Comment Set D.10: Brian A. Smith

Proposed Antelope-Pardee 500-kV Transmission Project

Response to Comment Set D.10: Brian A. Smith

BELCARO COMMUNITY

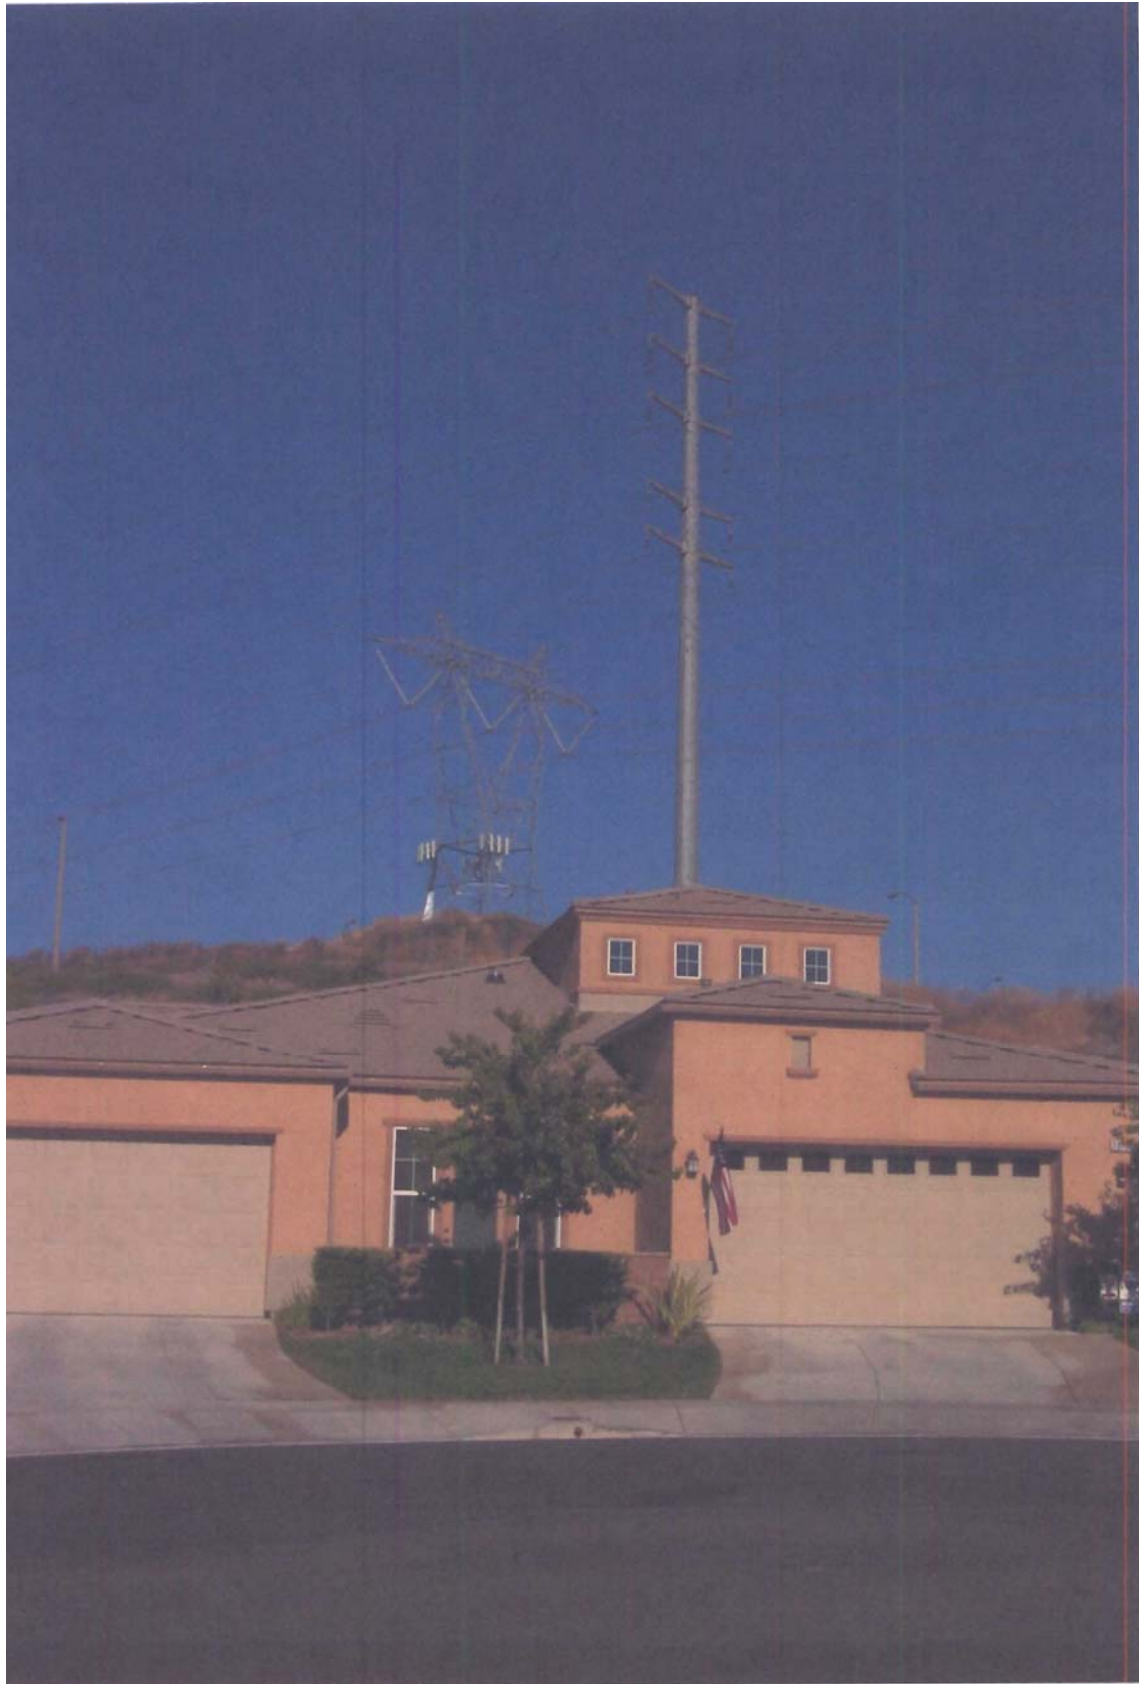
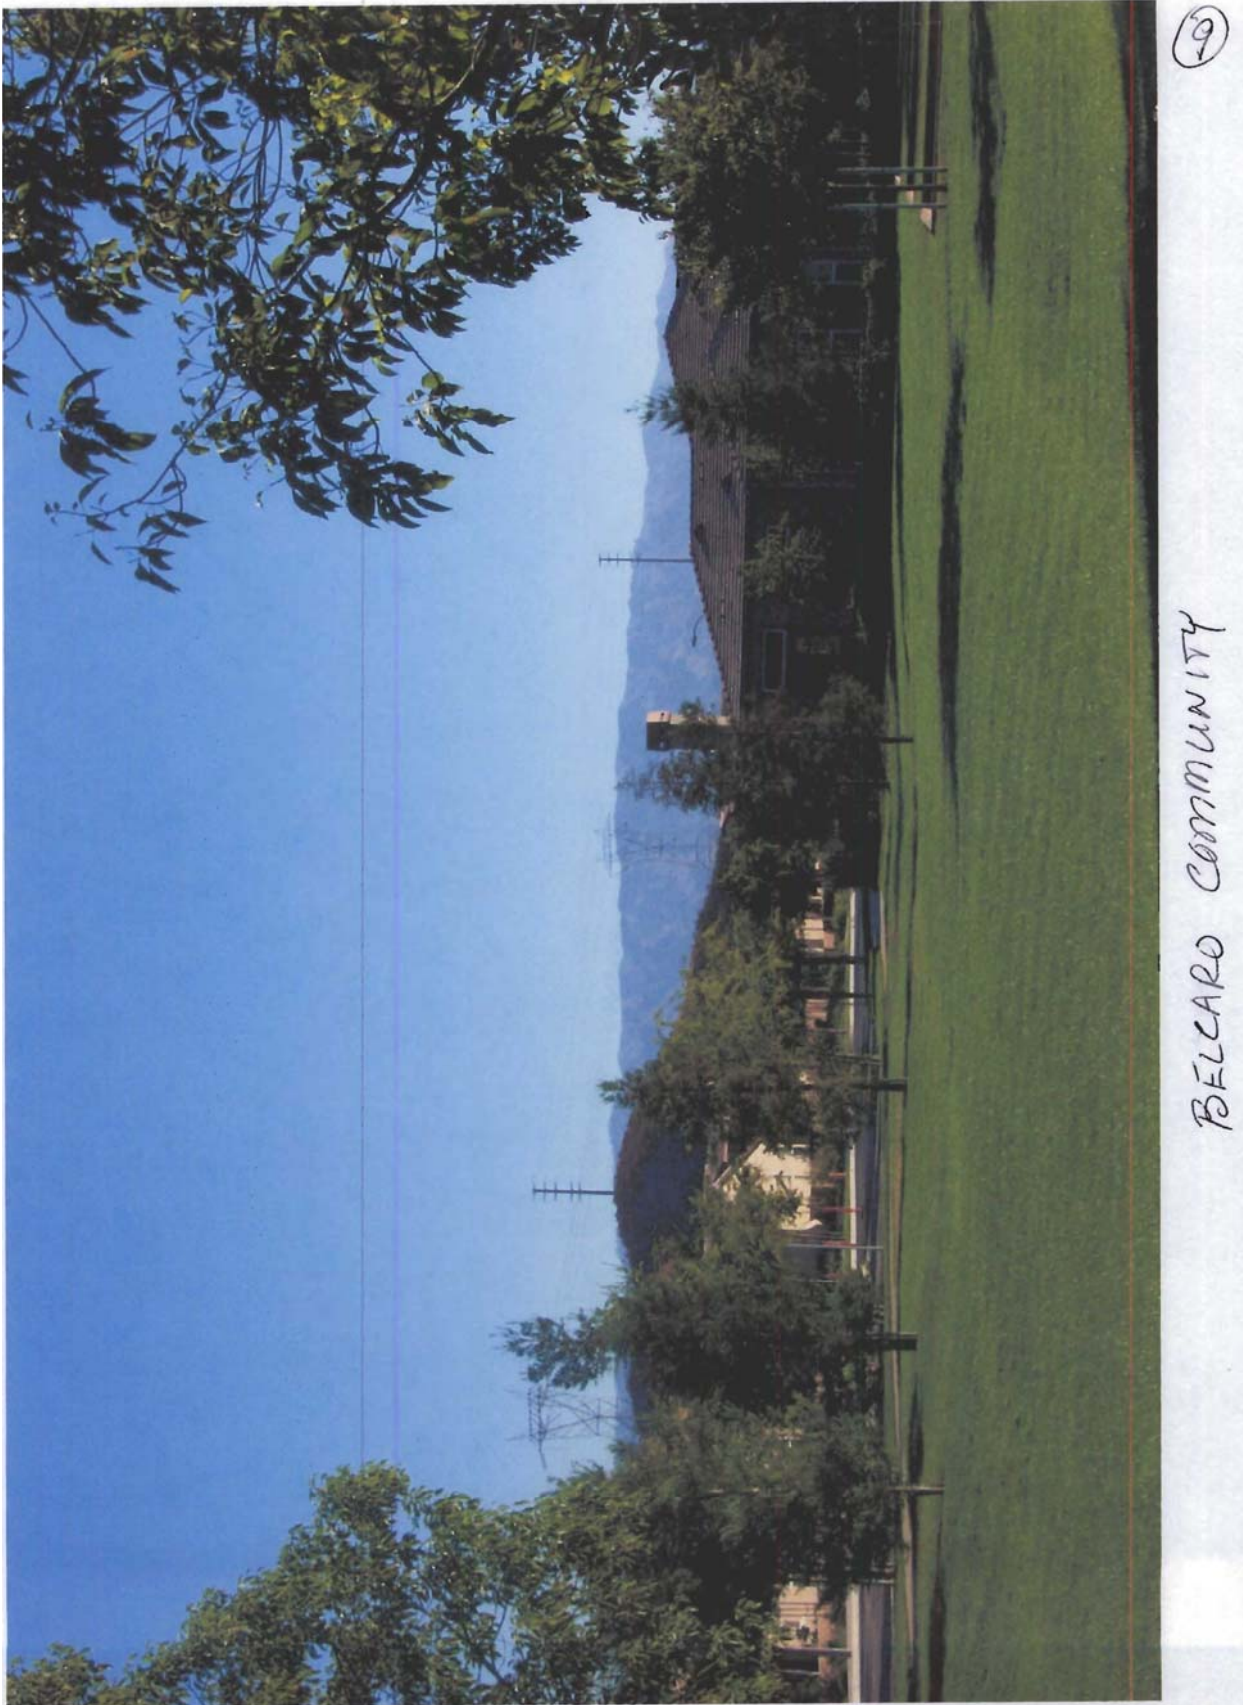
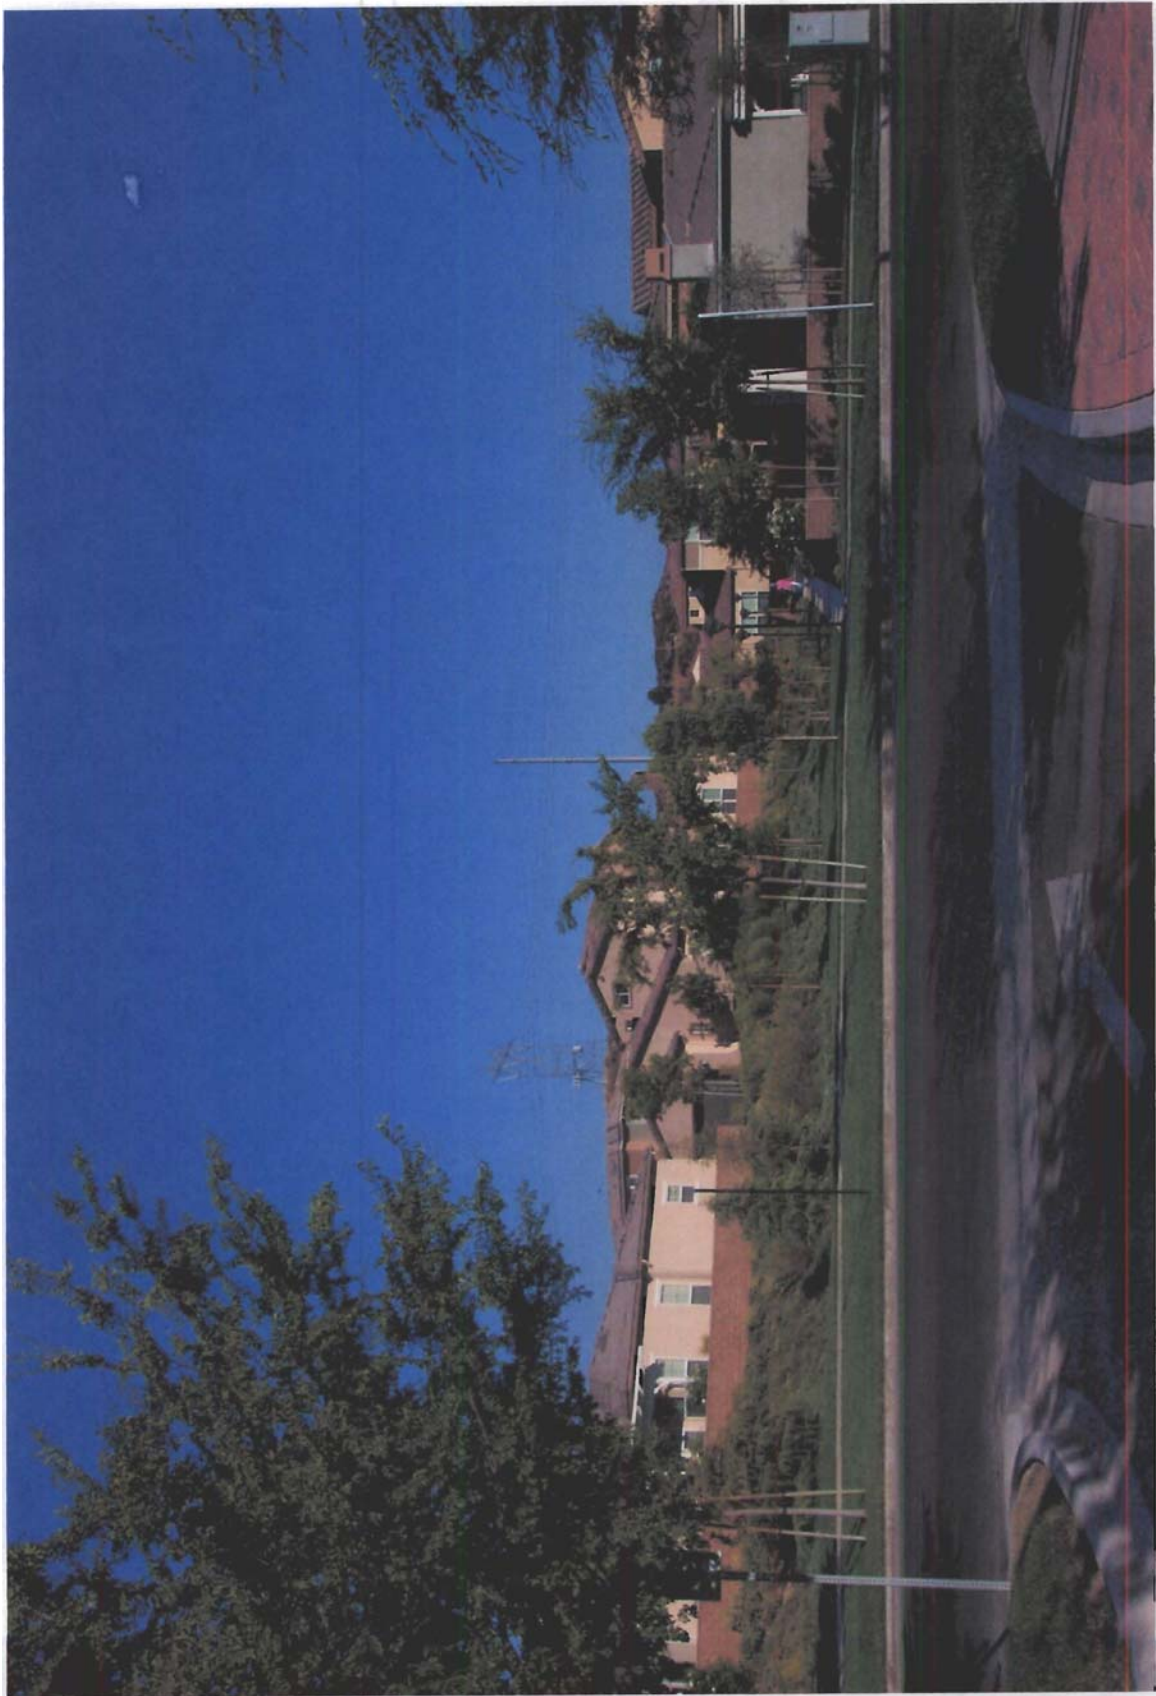
mono pole towers. This will reduce the visual impact rather than the existing proposals that will have negative impact on the views on Mile 22.3 through mile 25.6. I also believe the EIR does not properly address the EMF impact of alternative no 3 in the area next to populated areas between mile 22.3 and mile 25.6. The EIR shows ~~no EMF~~ fails to show an EMF cross section effect for Alternative 3. I believe that the visual impact portion of the EIR should include a study of the effects of both the proposal and alternative 3 ~~for~~ on our neighborhood. (THE COMMUNITY IS NAMED BELCARO)

D.10-2
cont.

D.10-3

D.10-4

D.10-2 Please see photographs and visual simulations at the end of Section C.15. Please refer to visual simulations of KOP 10, which is representative and characteristic of many views within the suburban neighborhoods of the Santa Clarita vicinity. Simulations of KOP 10 show (1) existing conditions; (2) the proposed Project with double-circuit lattice steel towers; (3) visual mitigations with double-circuit tubular steel poles; and (4) Alternative 3 with a second set of 500-kV lattice steel towers.

D.10-4 As noted in the responses to Comments D.10-1 and D.10-2, KOP 10 was selected because it is representative and characteristic of many views within the suburban neighborhoods of the Santa Clarita vicinity. It is impractical to provide simulations from every affected neighborhood along the proposed and alternative routes, and conclusions about visual impacts and proposed mitigation measures would not change if visual simulations were prepared for the Belcaro Development.
